8511 15th Avenue NE - DPD Project # 3006480

Design Review Board Recommendation Meeting - March 3, 2008

INTERIOR SETBACKS: Section studies of 6'-0" setback conditions

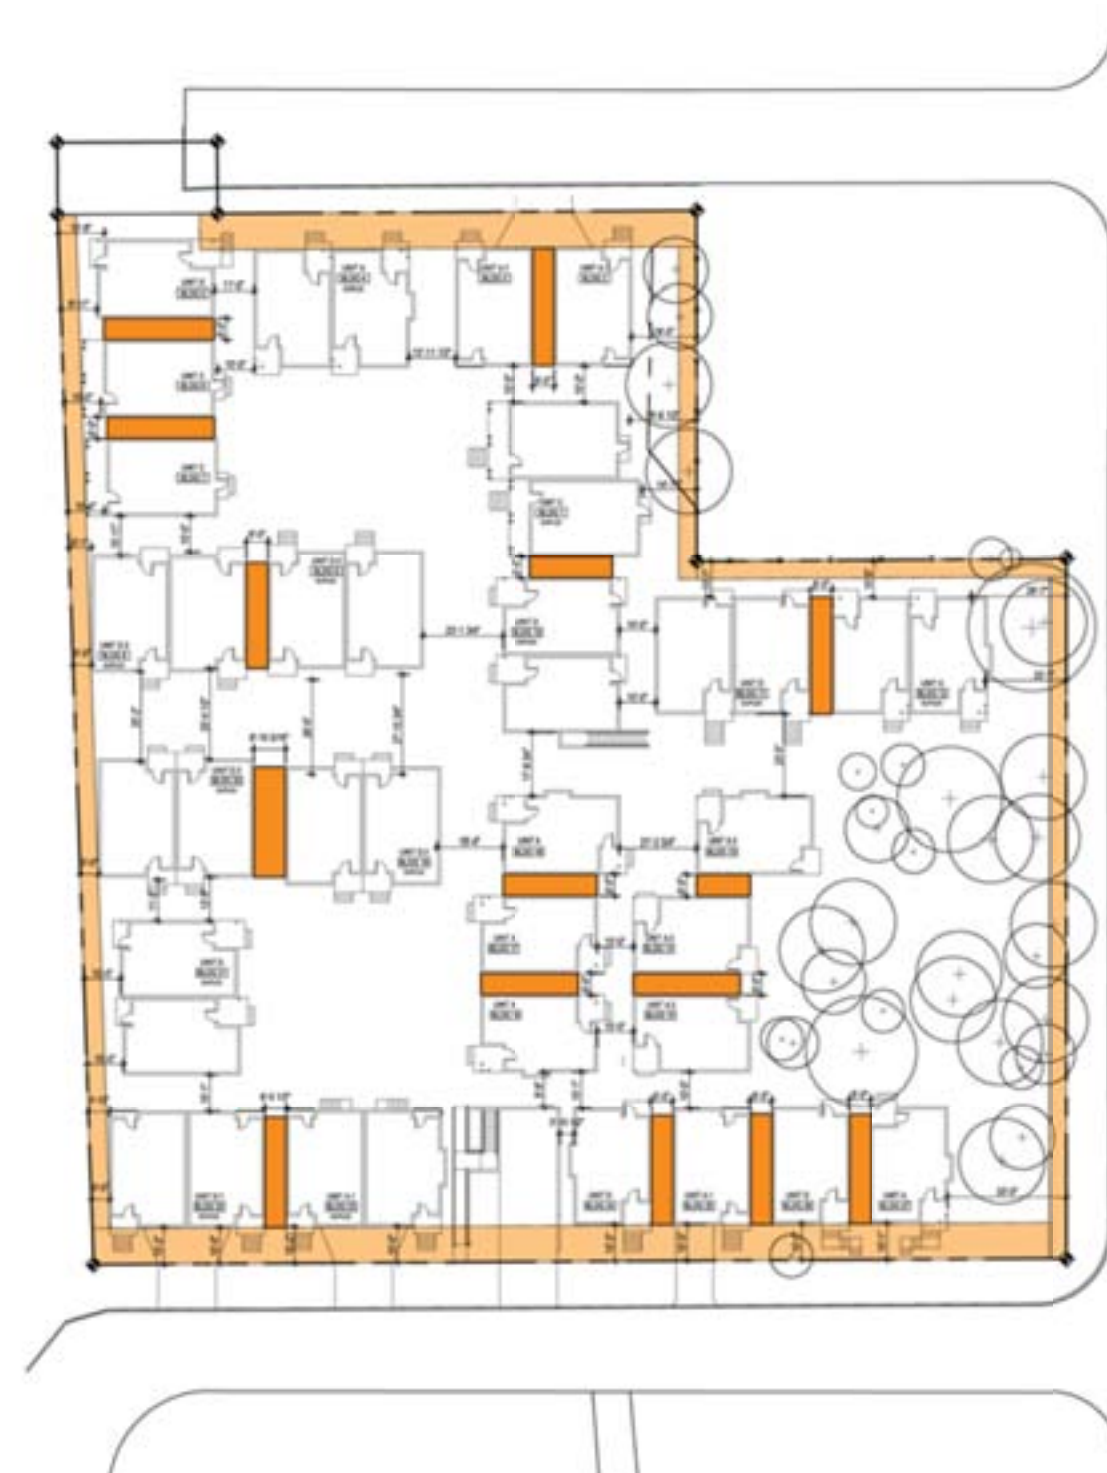
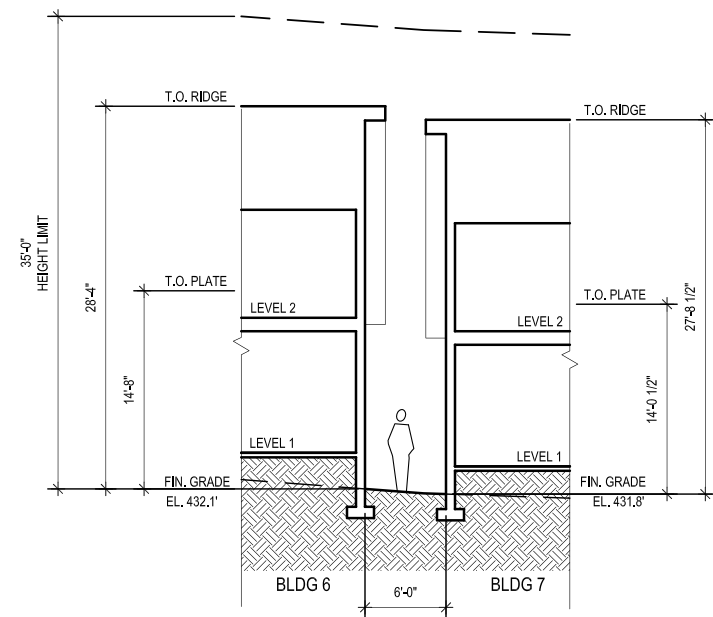
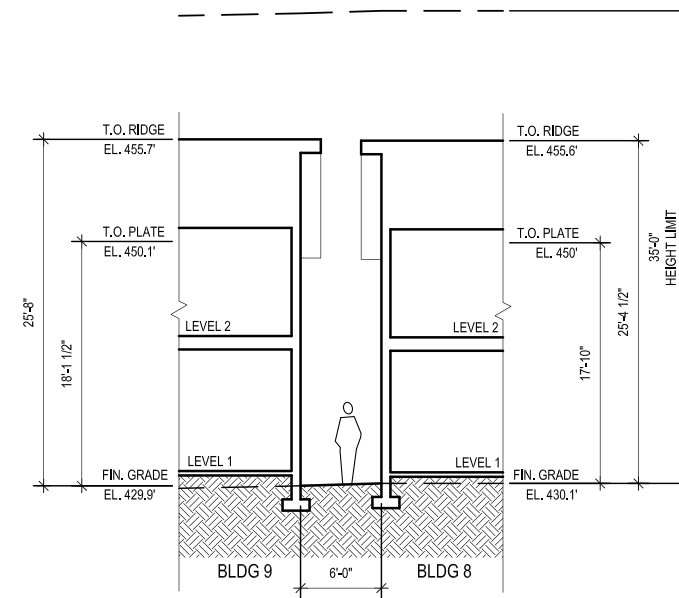
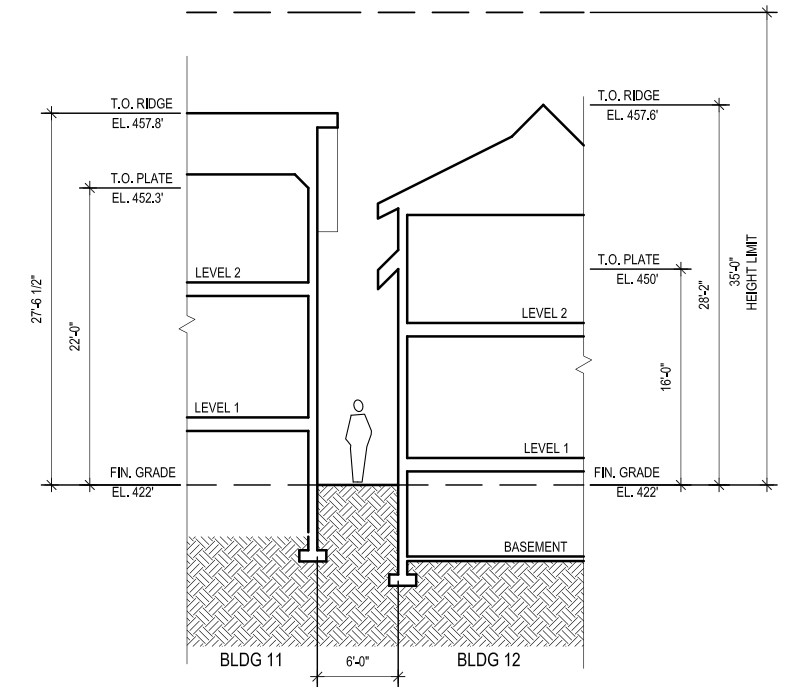
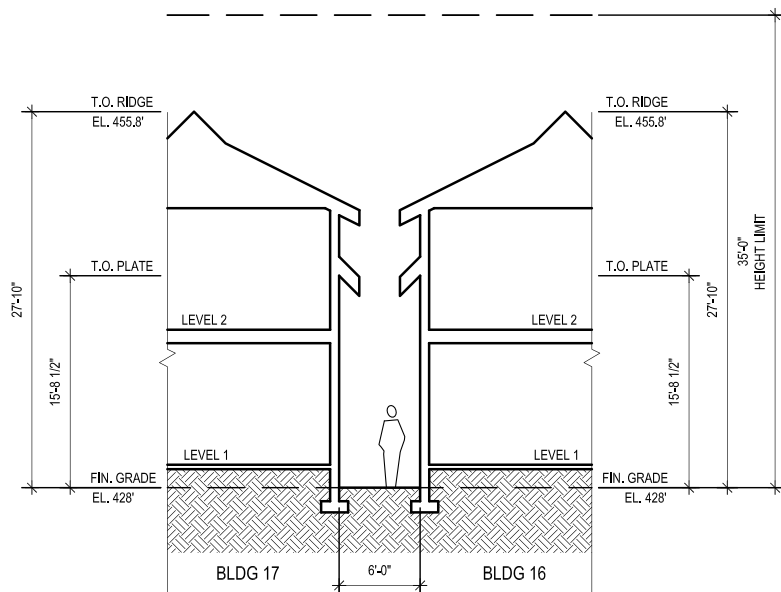
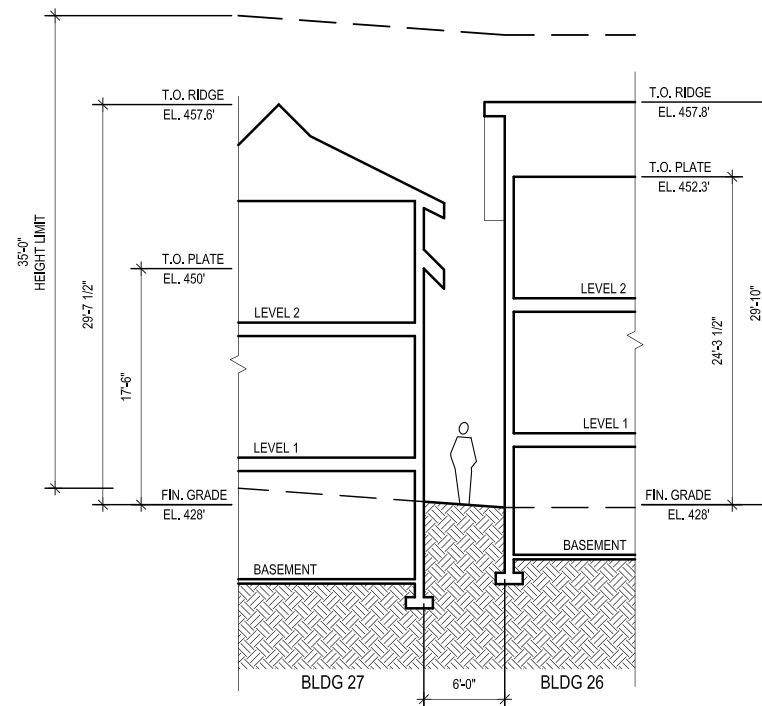
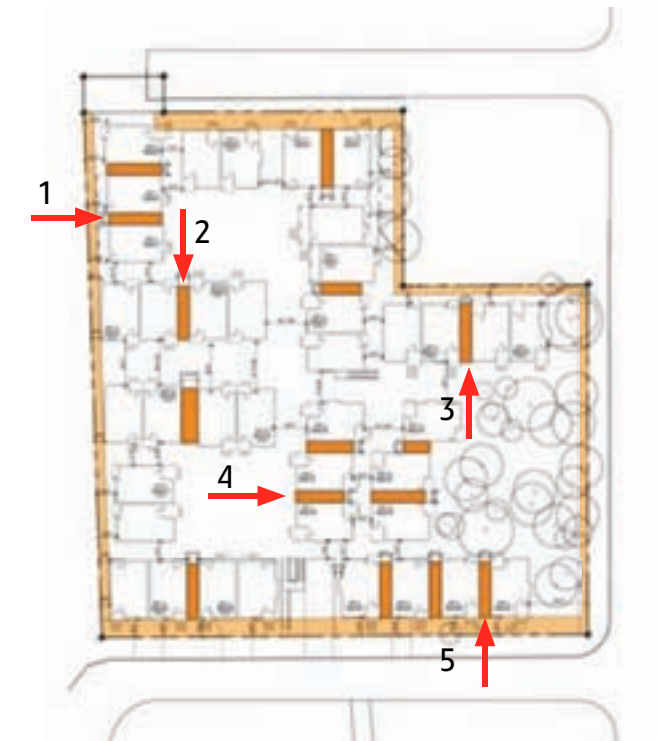
DRB: The requested 6-foot interior setbacks will require mitigation to limit tall, narrow spaces. Explore different massing, lowered rooflines, and human scale elements.

The applicant is requesting that the minimum interior setback be 6 feet.

Reducing the minimum interior setback allows open space to be consolidated into generous common areas while maintaining a mix of detached homes and duplexes. The average interior setback is 17.7 feet, greatly exceeding the code requirement.

In response to the Design Review Board's concerns, the site design includes a variety of building types with care taken to bring rooflines down and to create human-scale elements such as porches and window bays at the ground level. The 6-foot setbacks are limited to facades that do not contain primary entrances. In addition, many of these setbacks will be incorporated into the landscape and stormwater drainage plans as swales and bio-retention planters.

PROJECTIONS INTO SETBACKS

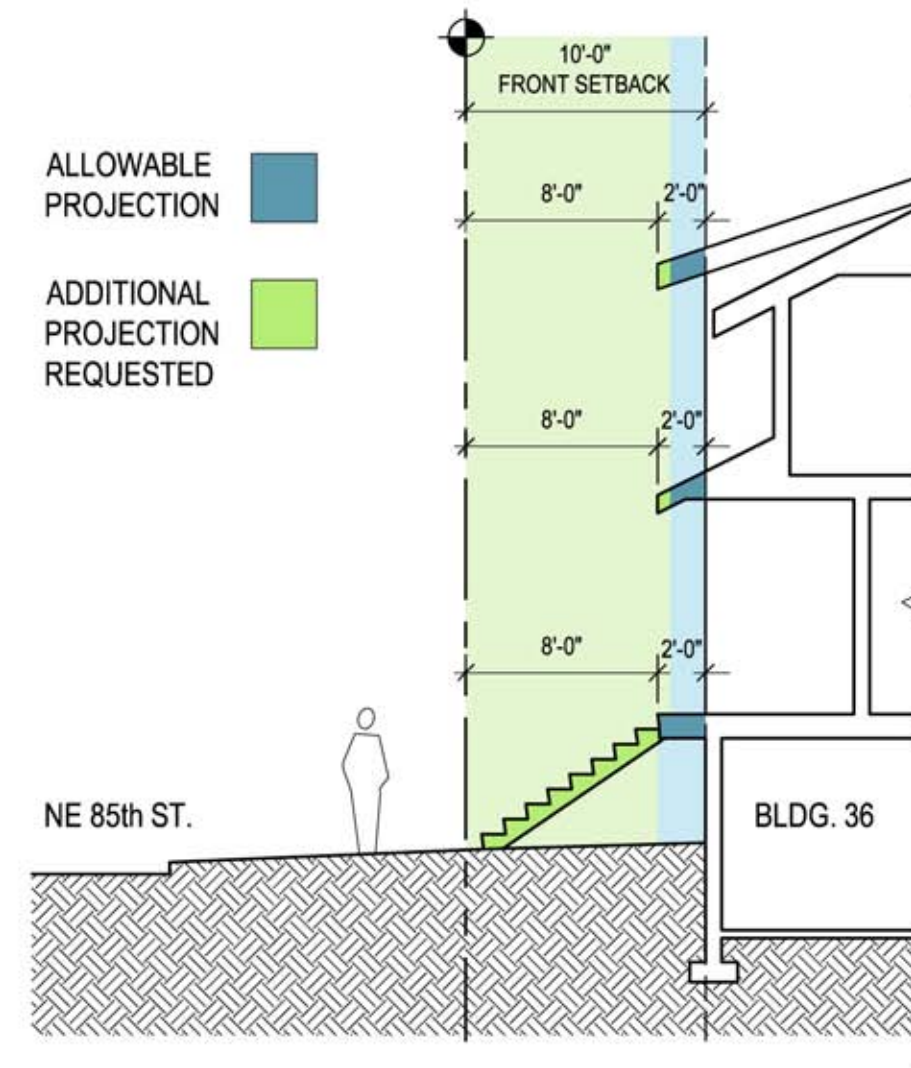
The applicant is requesting that eaves be permitted to project 24 inches into the required setback where that setback is 10' or greater.

The applicant is requesting that steps be permitted to extend into the required front setback.

Increasing the projection of the eaves to 24 inches will allow the design to reflect more closely the variation in the roof forms that are found in the surrounding neighborhood.

Because the ground naturally slopes down from the back of units on 85th to the sidewalk, these units are designed with basement living space. In addition, 7 of the proposed homes facing 85th and 86th have lower-level garages accessed from the street. SDOT's driveway standards limit how low the floor of that garage can be set, so these units are design with entrances mid-way between the garage level and the main living areas. As a result, the porches for the units on 85th and 86th are from 42" to 60" above grade.

Extending steps into the setback will connect these homes to the sidewalk level with traditional, human scale elements. The steps can also provide informal areas to sit and interact with neighbors and create a transitional zone between public and private areas.

CURBCUTS AND DRIVEWAYS

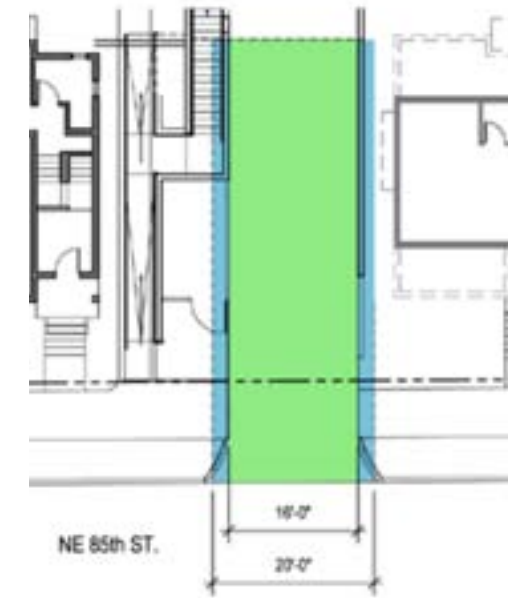
DRB: Limit curbcuts and parking access points, particularly at the southeast corner of the site.

The applicant is requesting that the two-way drive that serves the underground parking be 16 feet wide.

The applicant is requesting that 2 curb cuts on 85th and 1 curb cut on 86th be allowed to be 16 feet wide.

The placement of the underground parking garage and the homes adjacent to it is restricted by the location of existing trees and by the dedicated open space at the corner of 15th Ave. NE and NE 85th. A 16-foot driveway will allow more space to be given to the primary pedestrian entrance to the project and allow for a buffer between the public path or drive and the homes next to them.

In order to limit disruptions in public pedestrian walkways while meeting the parking needs of the site, curb cuts are shared between two separate units. Allowing an increased width in the curb cut will allow safer backing for two units without increasing the overall number of cuts.
